ADDITION TO 7106 POPLAR AVE. TAKOMA PARK, MD

Staff Item
Anne Fothergill
August 13, 2008

MEMORANDUM

MONTGOMERY COUNTY HISTORIC PRESERVATION COMMISSION
STAFF REPORT

1 NEW RIGHT SIDE ELEVATION
 A-3 SCALE: 1/4" = 1'-0"

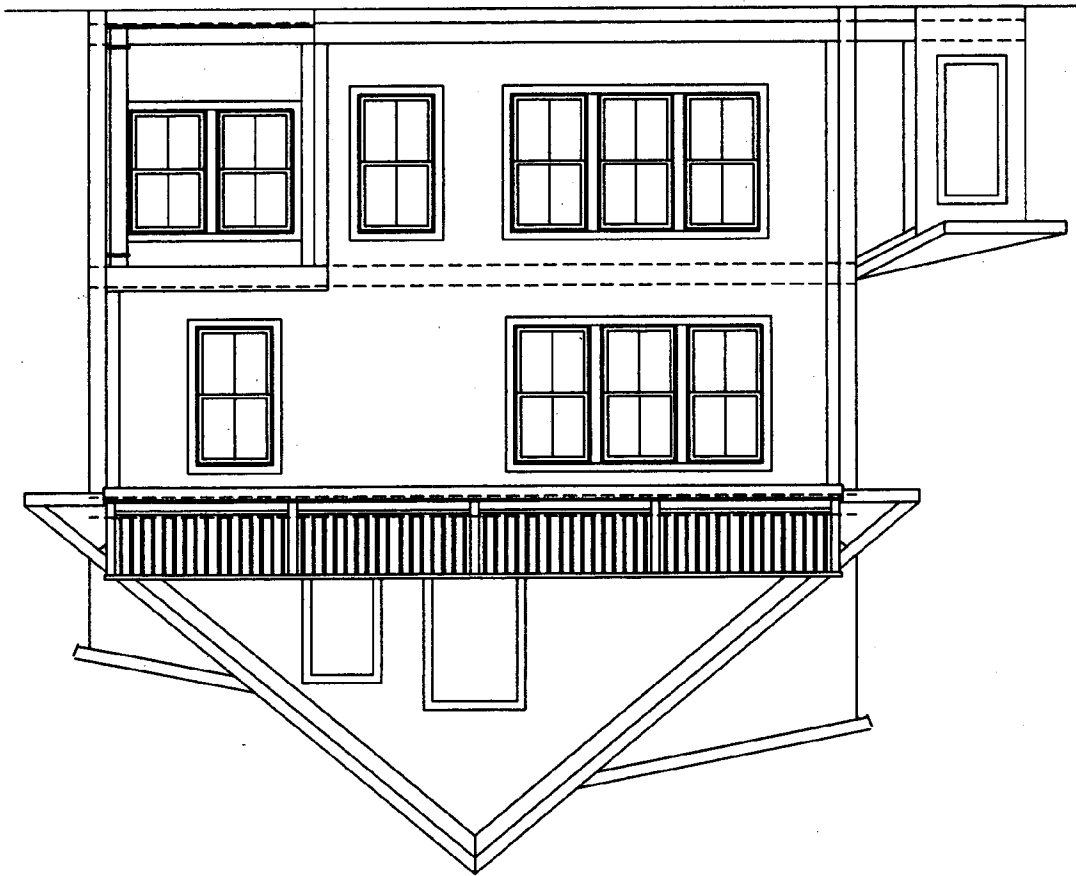
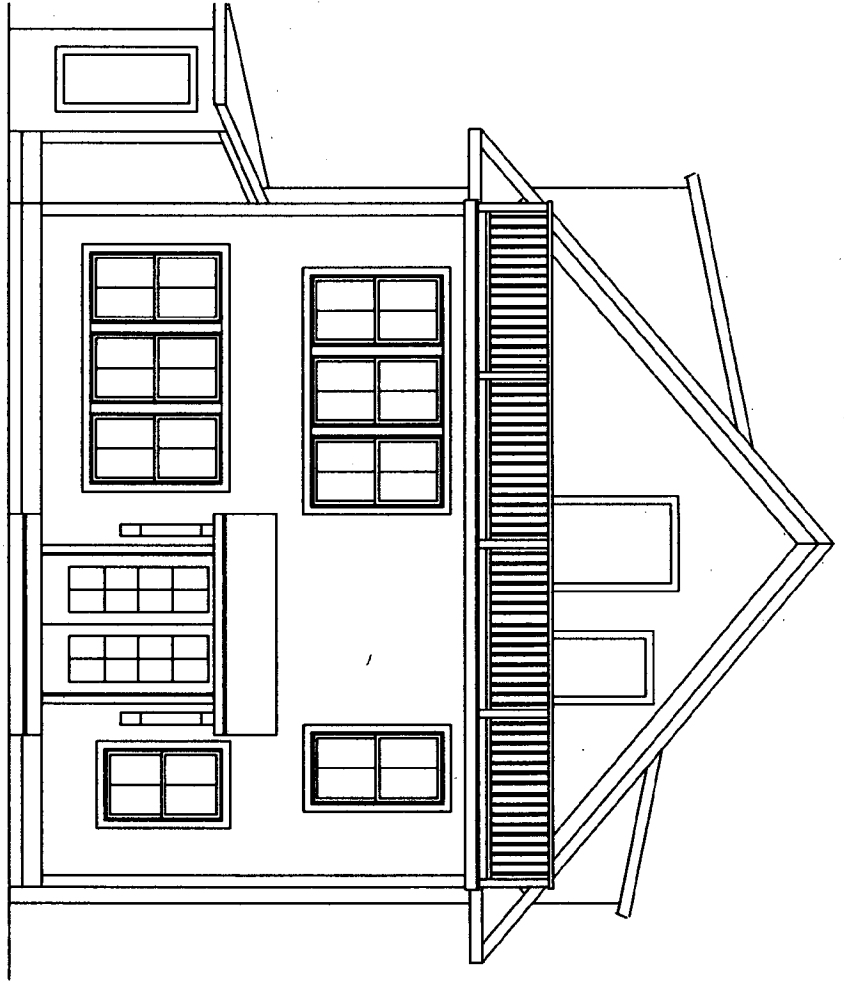
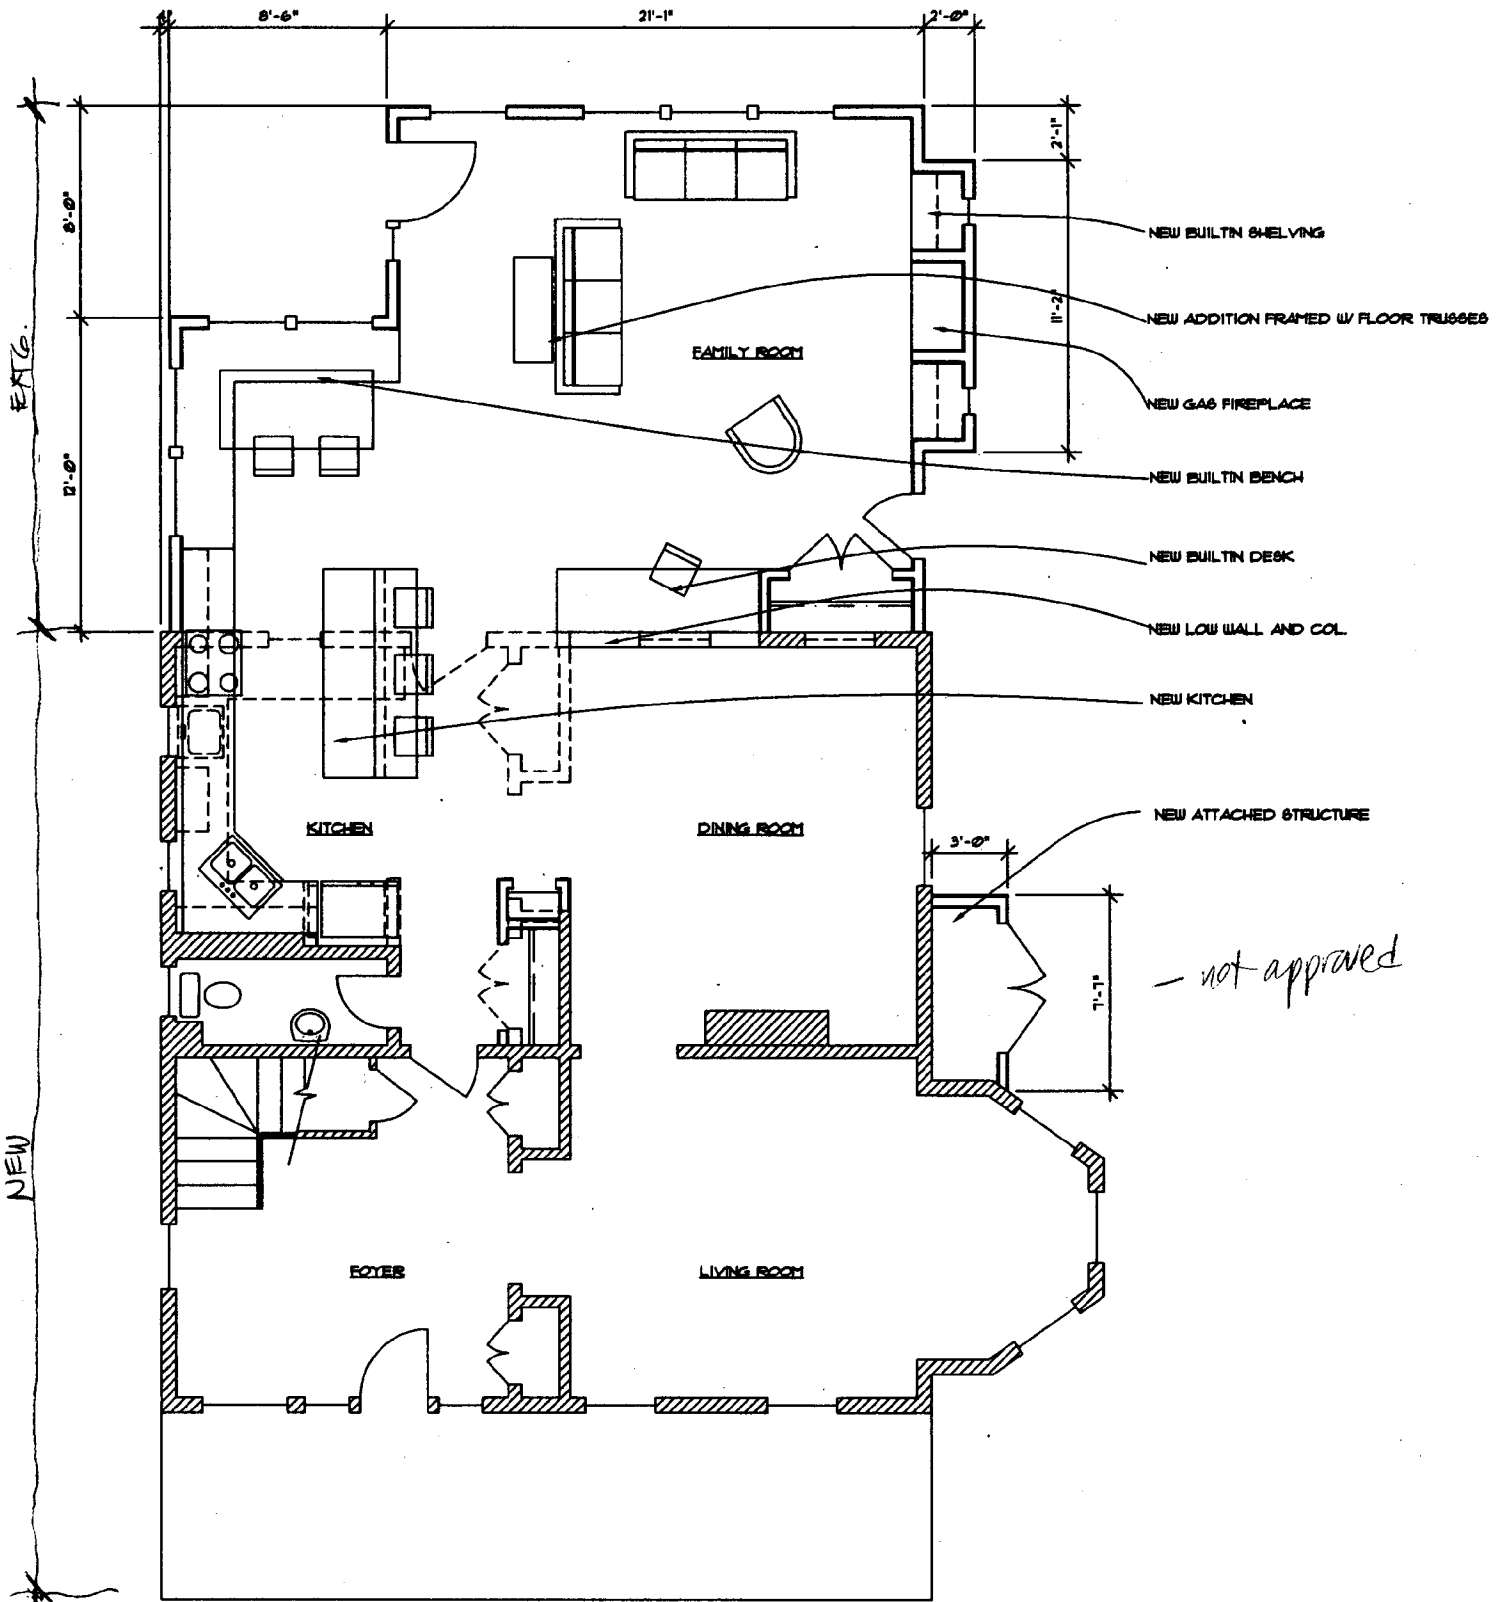
The project located at 7106 Poplar Ave has been revised since the approval we had in the spring. After they got some preliminary estimates and they reconsidered the restraints of the back yard, the clients decided that we needed to scale back a little bit. The previous addition came out from the back of the house 20'. Now we are looking to have the addition come out 17'. With this decrease in depth we could not accommodate the small recessed porch that we originally designed. Now we have a simple addition with a small roof projection over the door at the rear. The projection on the right side is consistent with the original but we now only have one window instead of two. Essentially the rest of the design is the same.

not approved

yes - HPC approved
12-5-07

1 NEW RIGHT SIDE ELEVATION
 A-3 SCALE: 1/4" = 1'-0"

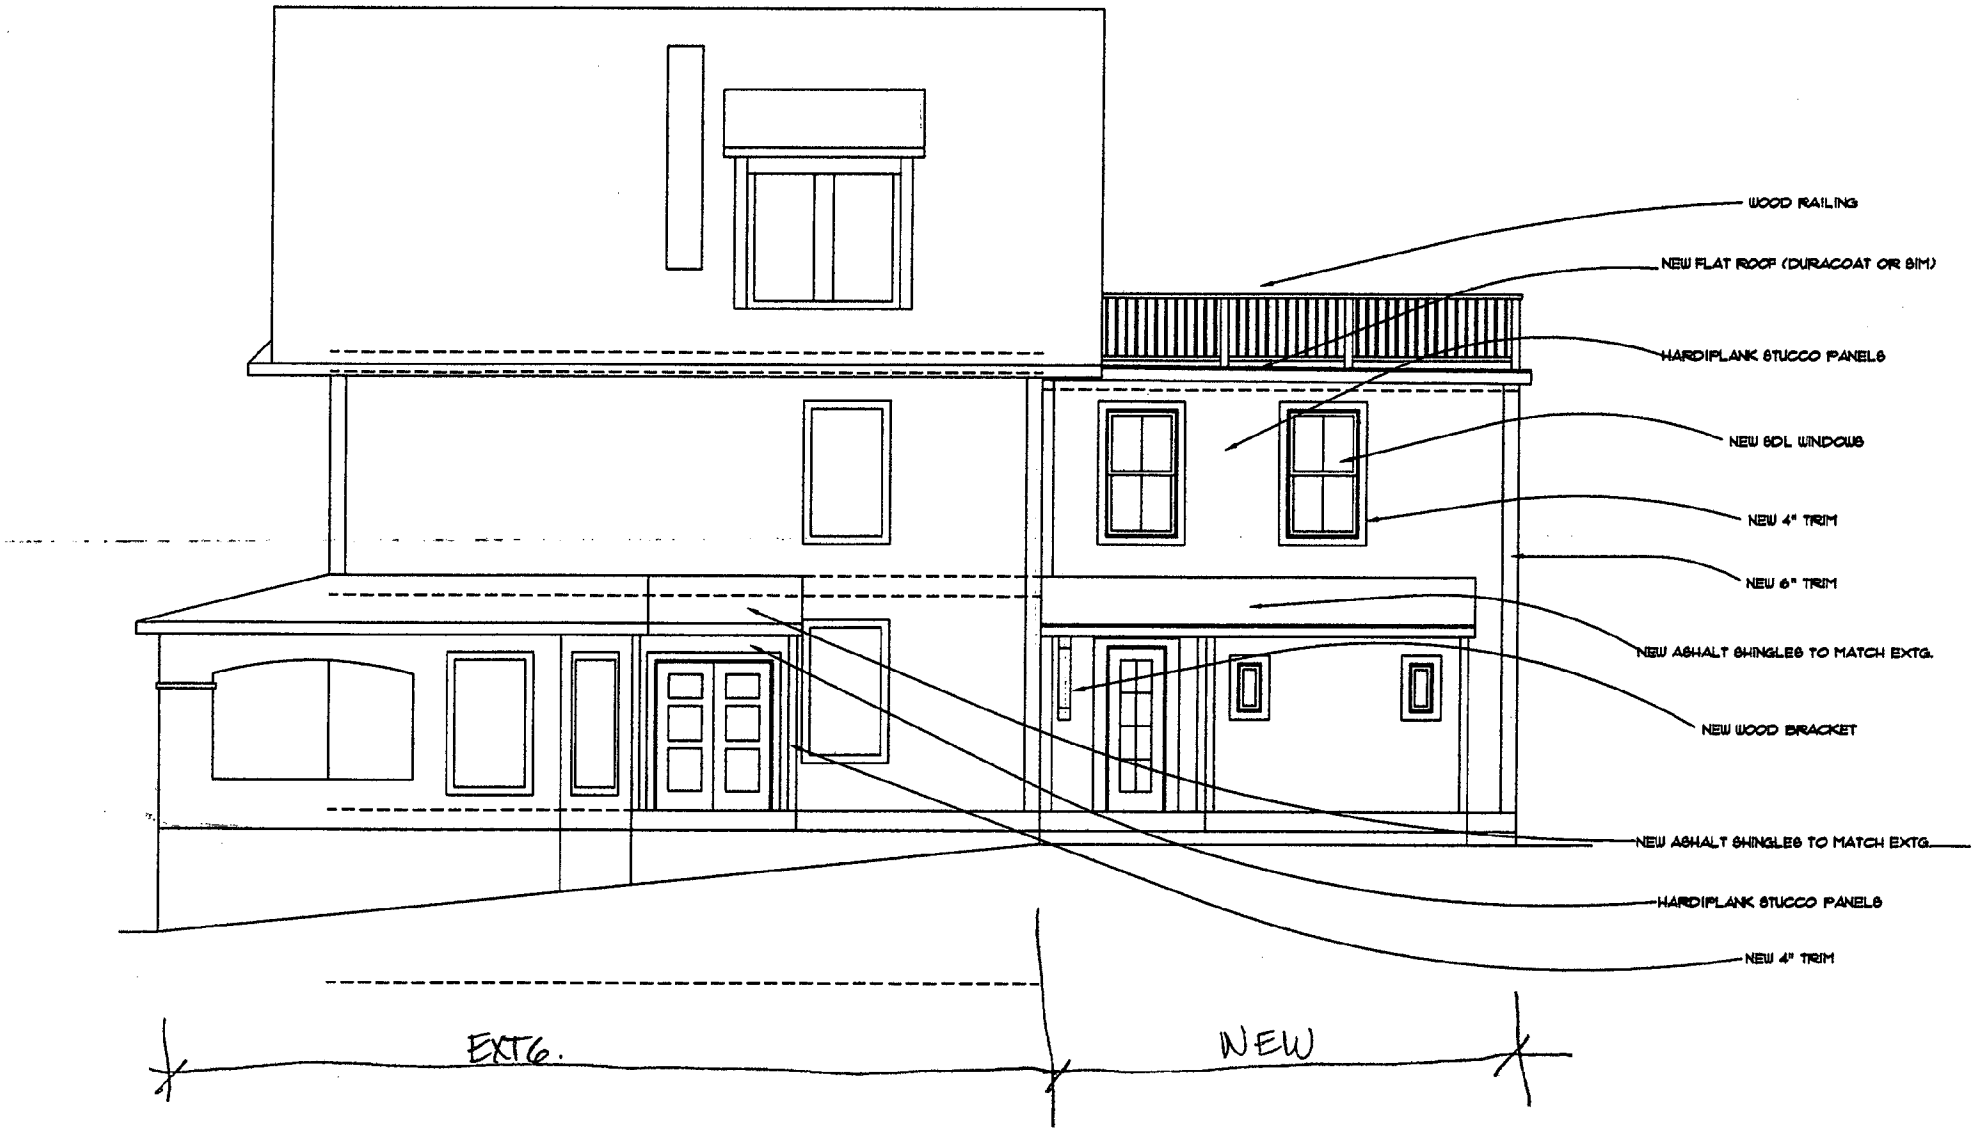
One area of concern is the rear right side of the new addition where two very small windows are proposed. These seem not to be in keeping with the historic house and even though they are located towards the back of the house, staff would recommend that their design be revised and submitted to staff for approval.
